The Sir Robert Ogden Evans Property Partnership Ltd
Proposed Residential Development, Dunningley Lane, Tingley

Stage One Road Safety Audit Designer's Response

4 December 2017
Version 1.0
Issue

SCALE@1:200

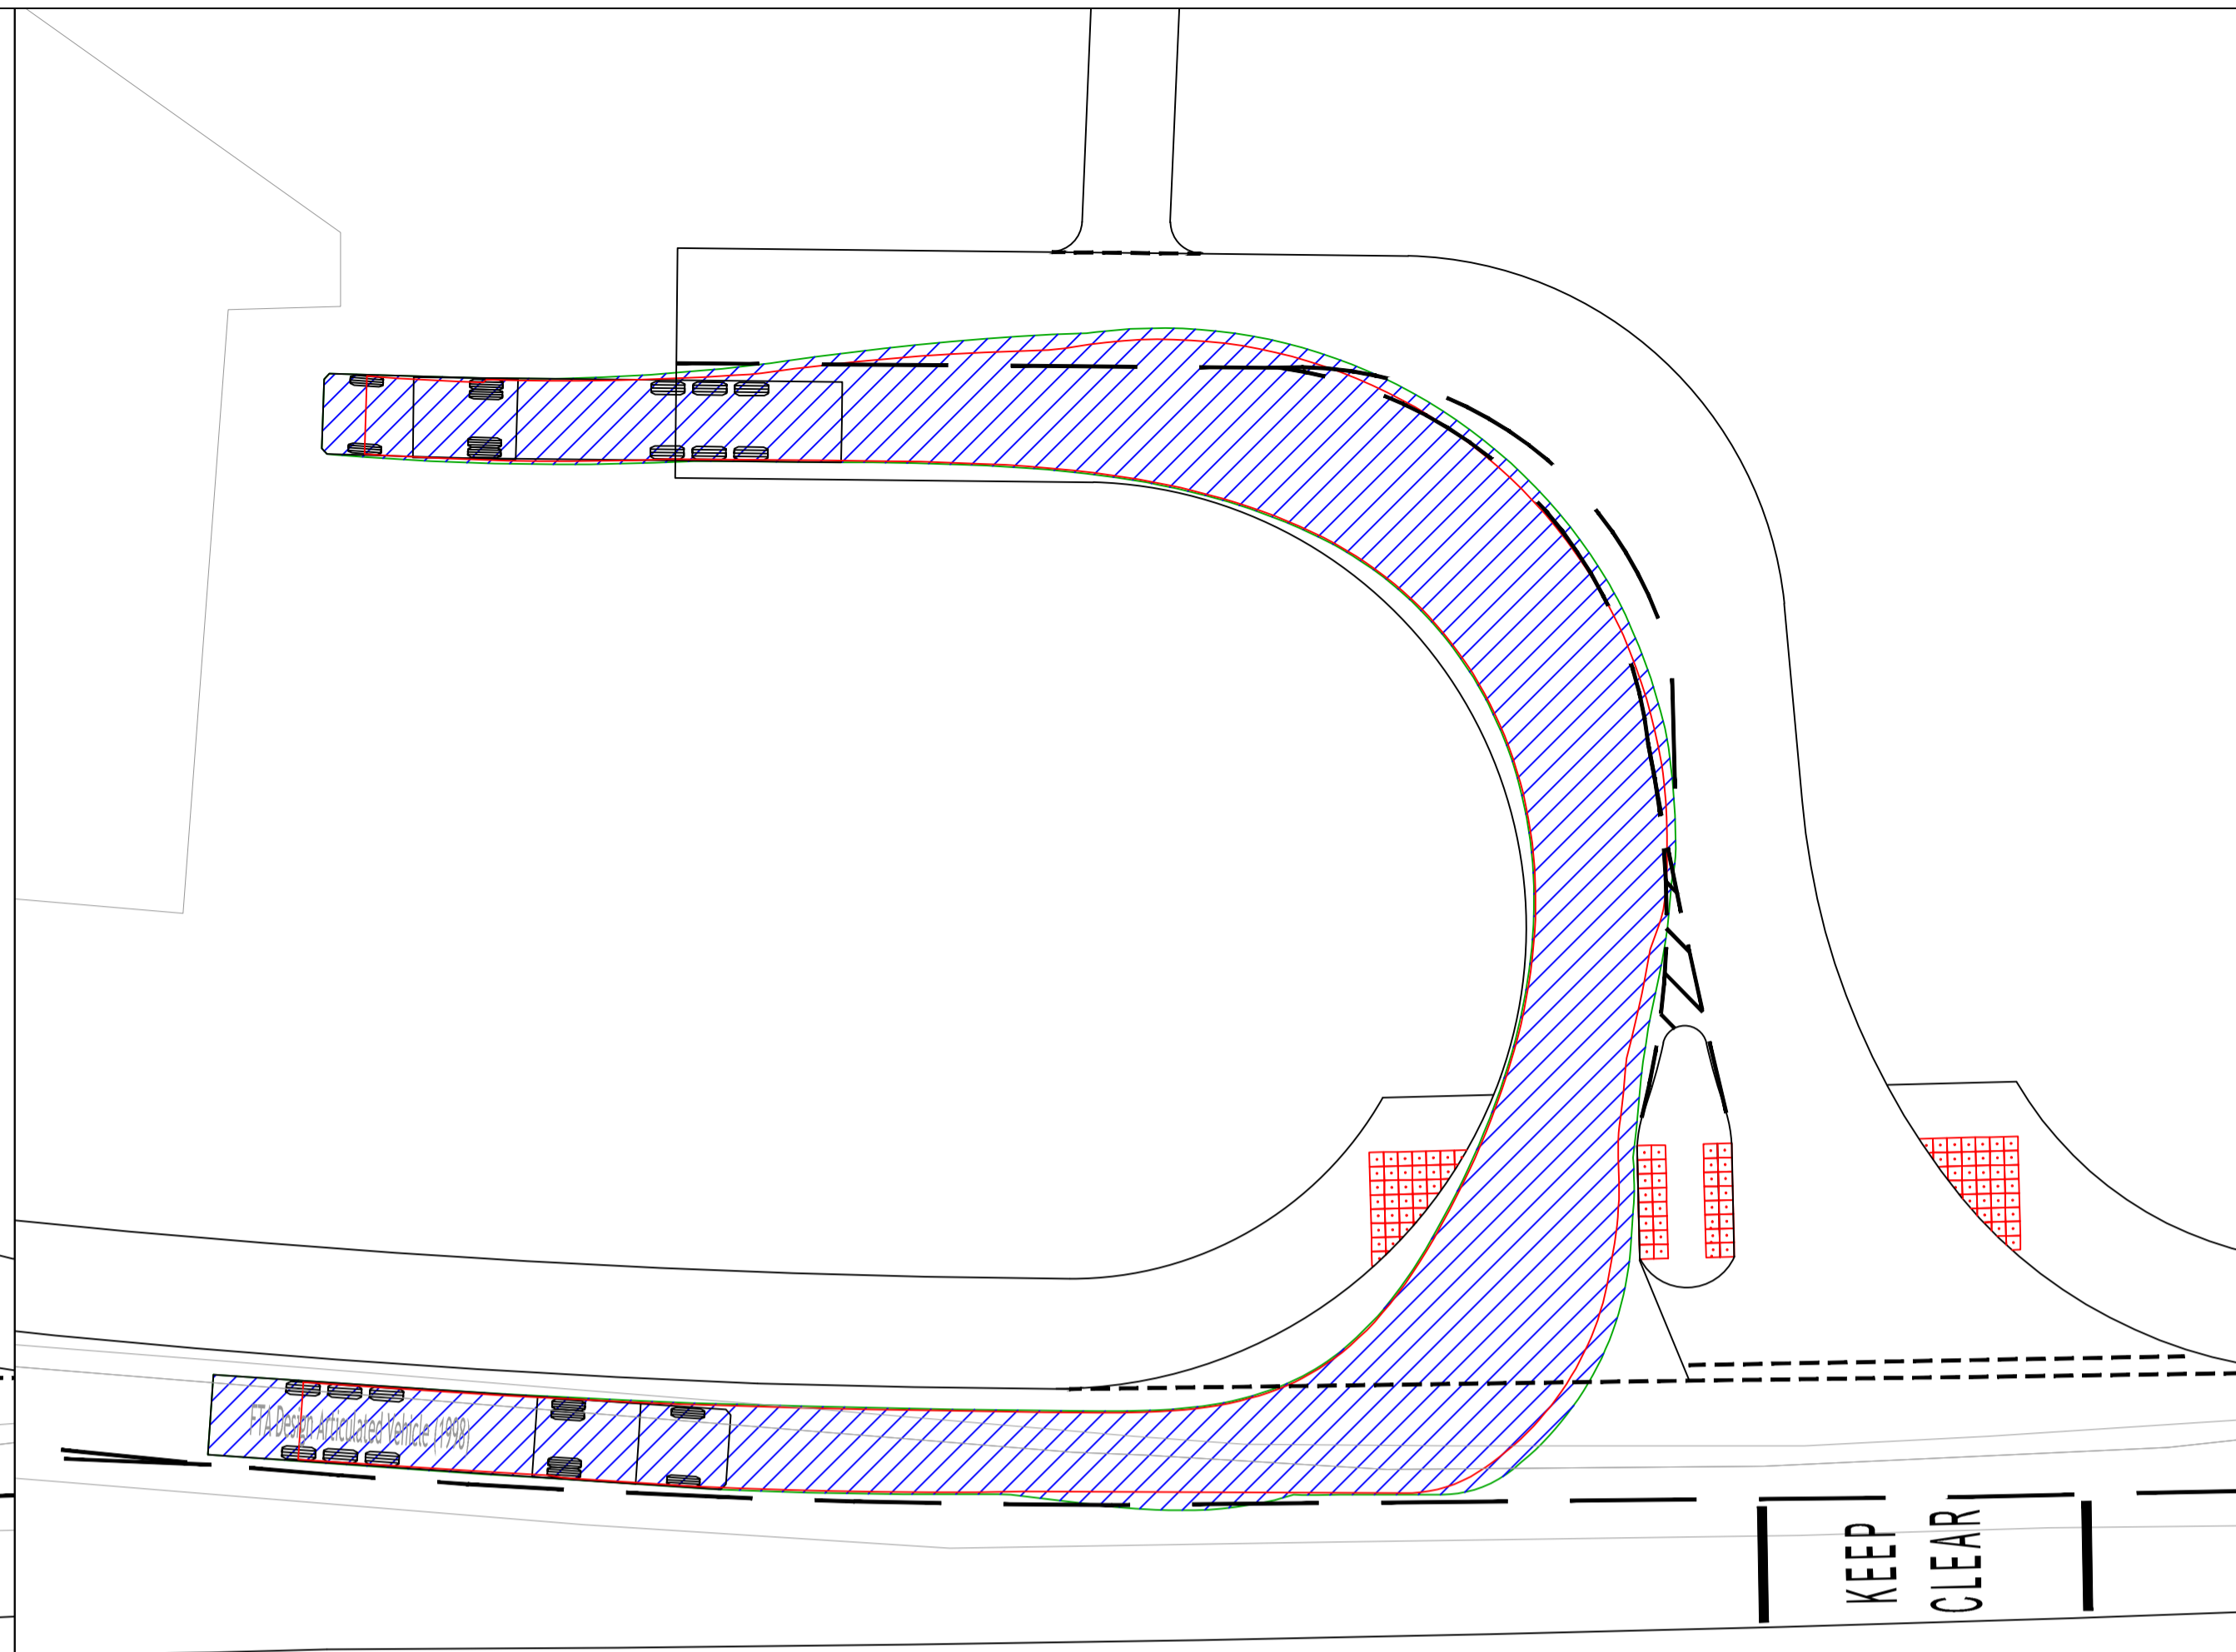
Location:	New development access junction with A653 Dewsbury Road
Summary:	Tight entry/exit to depot
Description:	The proposed eastern entry/exit from the depot from local road into depot is very tight. The swept path drawing supplied shows that opposing long vehicles could not pass each other safely on the bend. The depot access, is in constant use by traffic officers and will, at times be required to pass large or abnormal loads (periods of frequent gritting etc.), with an associated risk of head on and side swipe collisions. The access should be designed with a geometry which allows free flow of all vehicles.
Recommendation:	It is recommended that formal consultation with A-one+ / Highways England is undertaken as part of the detailed design process, to establish the exact level of usage and the required geometry.
Designer Response:	Recommendation accepted. Based on information derived from traffic surveys undertaken at the junction, movements by large vehicles are infrequent, and it is extremely unlikely that large vehicles would need to pass each other in practice. Notwithstanding this, further formal consultation with Aone+ and Highways England will be undertaken as part of the detailed design process.
